Access Compliance Report

Public Rights-of-Way

Intersection ID: 23148	Main Street: ALEXANDER_RD	Cross Street: HARRISON_RD	Location: NE
ADA ID: 6B536CA43D35	Ramp Type: Perp	Initial Pass/Fail: Fail	Overall Compliance: No
Severity Score: 26.25			
Codes/Mitigation Info/Possible Solution		Field Measurements/Component Compliance

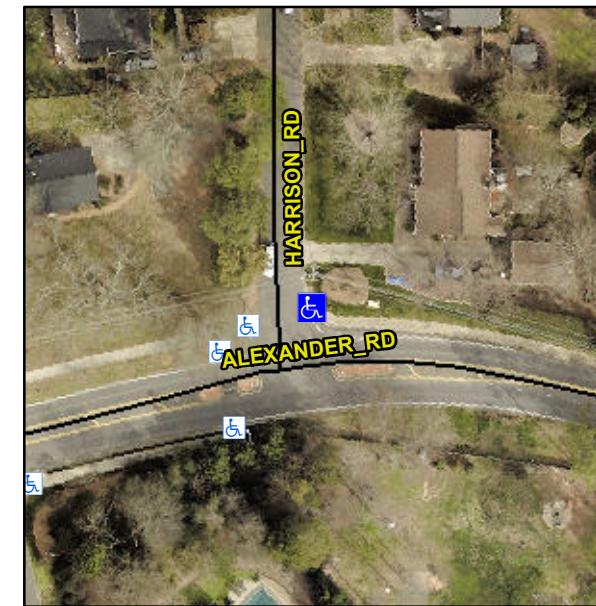
Not Found, R304.2.2, R304.5.3

Compliance	Description	Data	Compliance	Description	Data
N/A	Ramp Length (in)	48.0	No	Ramp Slope (%)	14.4
Yes	Ramp Width (in)	48.0	No	Ramp XSlope (%)	3.6
N/A	Flare Type LT	N/A	N/A	Flare Type RT	N/A
N/A	Flare Slope LT (%)	N/A	N/A	Flare Slope RT (%)	N/A
N/A	Flare Traversable LT?	N/A	N/A	Flare Traversable RT?	N/A
N/A	Landing Length (in)	N/A	N/A	DWS Provided?	N/A
N/A	Landing Width (in)	N/A	N/A	DWS Contrast?	N/A
N/A	Landing Slope (%)	N/A	N/A	DWS Length (in)	N/A
N/A	Landing X Slope (%)	N/A	N/A	DWS Full Width?	N/A
N/A	Landing Curb? (Y/N)	N/A	N/A	DWS Offset (in)	N/A
N/A	Shared Landing?	N/A			
N/A	Gutter Ponding?	N/A	N/A	Gutter Slope (%)	N/A
N/A	Gutter Lip Ht (in)	3.0	N/A	Gutter X Slope (%)	N/A
N/A	Painted X Walk1?	No	N/A	Painted X Walk2?	N/A
	X Walk 1 Direction	To W		X Walk 2 Direction	N/A
N/A	X Walk 1 Width (in)	N/A	N/A	X Walk 2 Width (in)	N/A
	X Walk 1 Slope (%)	3.3		X Walk 2 Slope (%)	N/A
	X Walk 1 X Slope (%)	2.6		X Walk 2 X Slope (%)	N/A

Remove & Replace Entire Ramp.
